**Item 5.****Development Application 19-21 Buckland Street, Chippendale - D/2022/1359**

File No: D/2022/1359

**Proposal Summary:** Alterations and additions to a former warehouse building including demolition of existing floors, facade retention and construction of an additional three storeys, and use of the site as an office premises.

**Figure 29:** East (Buckland Street) Elevation demonstrating building height in context of the RFB and Pioneer House

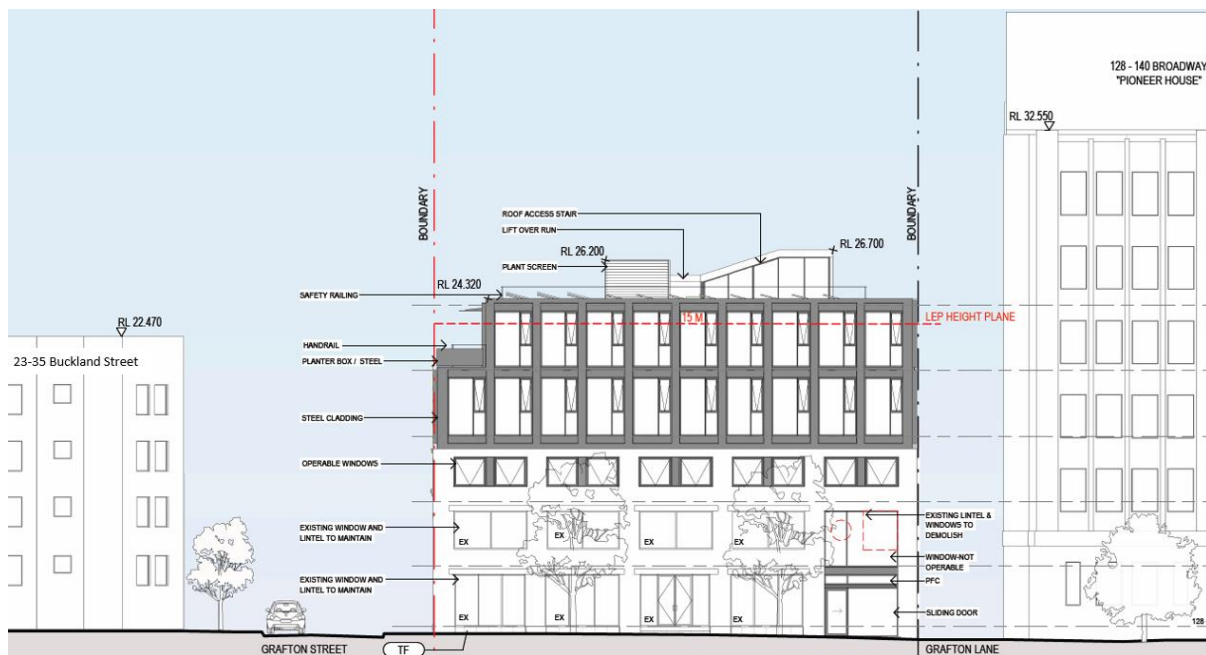
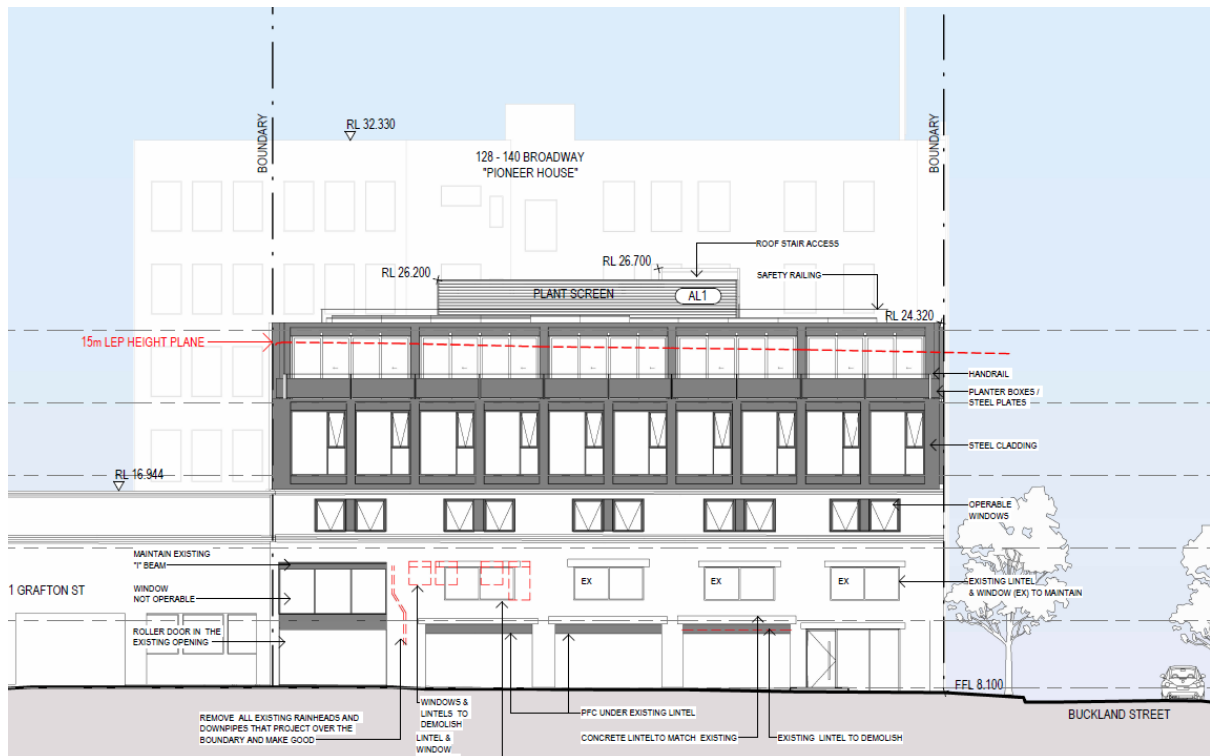
42. The site is subject to a maximum height control of 15m. The proposed development has a height of 18.74m. The proposed height is demonstrated in the below figures.

**Figure 31:** Proposed east elevation with the four-storey RFB seen to the left and the six storey Pioneer House seen on the right. Pioneer House also includes a rooftop billboard.

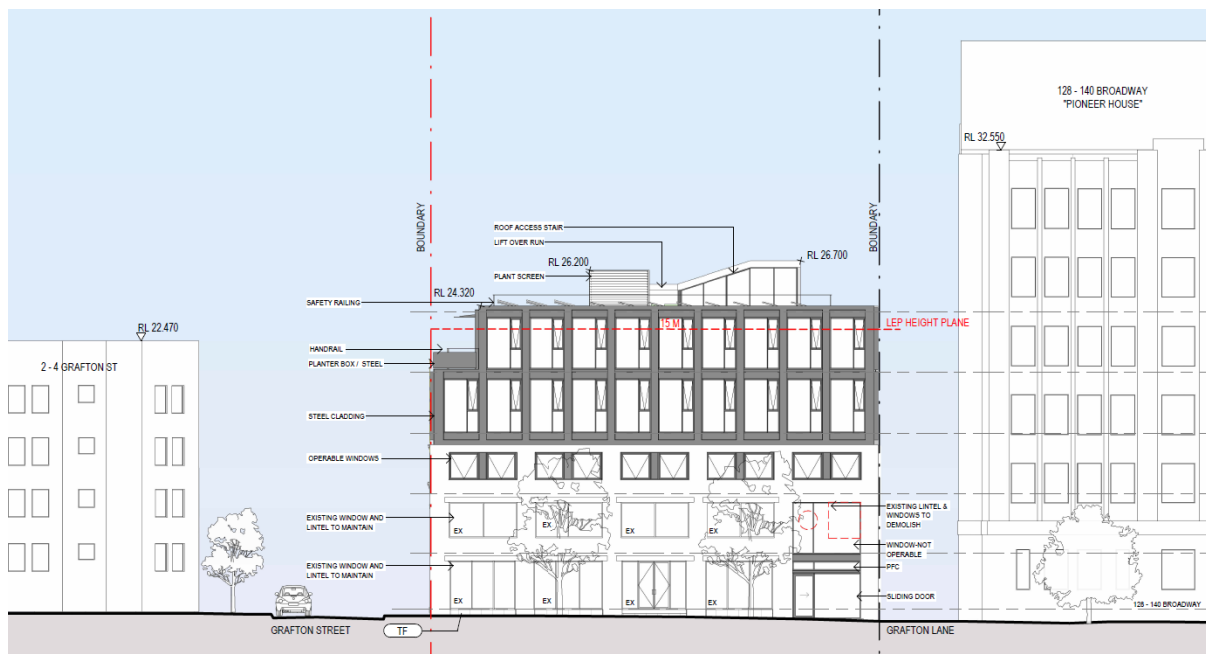
52. DCP Control 4.2.1.1 specifies building height in storeys. The proposed development is five storeys in height, which exceeds the four storey height control for this site. It is noted that the proposal is below the maximum Floor Space Ratio permitted for the site. The applicant has also demonstrated that the proposal presents a gradual transition between the neighbouring six-storey Pioneer House site to the north at 128 Broadway, Chippendale and the neighbouring four-storey RFB to the south at 23-35 Buckland Street, Chippendale. This transition is demonstrated in the below figure.

53. The proposed level 4 setback from the southern (Grafton Street) boundary minimises overshadowing impacts to neighbouring apartment (refer to further discussion below).
54. The proposed built form is appropriate in context of the site's surrounding environment and is supported.

**Figure 33:** Proposed rooftop landscaping

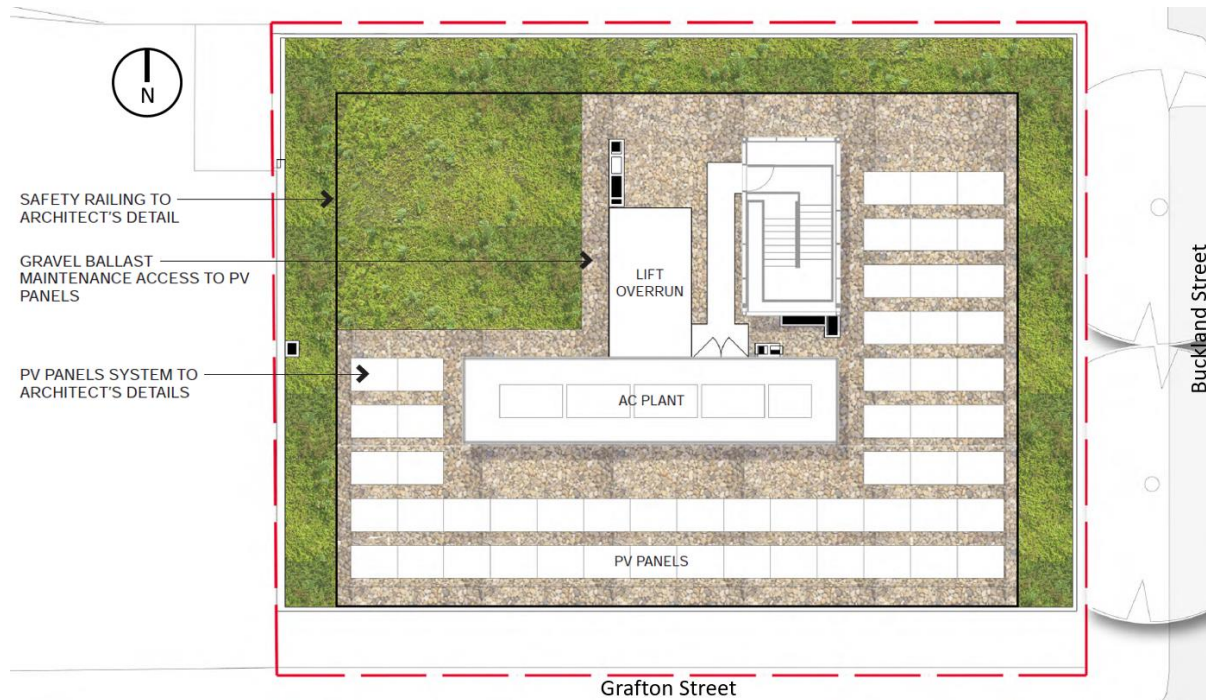
65. DCP Control 3.5.2 requires that a site achieve 15% tree canopy coverage within 10 years. As the proposal is for alterations and additions to a commercial building which currently includes total site coverage there are no existing trees on site. The application does not propose any additional tree planting. However, as the roof is proposed to be inaccessible the submitted landscape plans propose a substantial amount of rooftop planting consisting of low-lying shrubs. This alternative has been reviewed by Council's Tree Management and Landscape Units and is supported subject to conditions.

Figure 34: North (Grafton Lane) facade, with proposed bricked-in windows

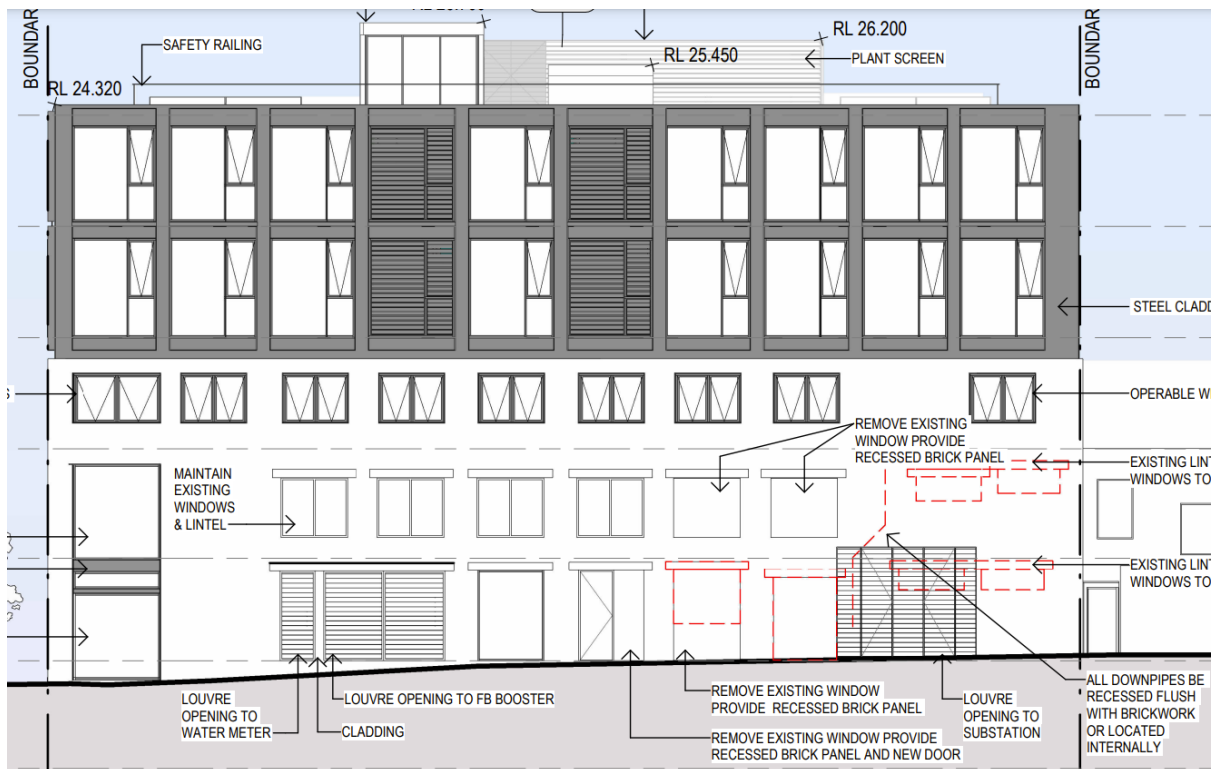
The application proposes the bricking-in of two existing windows to Level 1, along Grafton Lane. The applicant submits that the windows will not receive significant solar access and the bricking in of the windows is proposed for aesthetic purposes. Council's Heritage Specialist recommends that the windows be glazed, in-line with the remaining windows along Grafton Lane on Level 1, in order to reduce visual clutter, preserve the facade, and increase amenity within the building. The Heritage Specialist has also recommended the repointing of the brick facade. Conditions are recommended requiring the submission of these design changes to Council prior to the issue of a Construction Certificate.
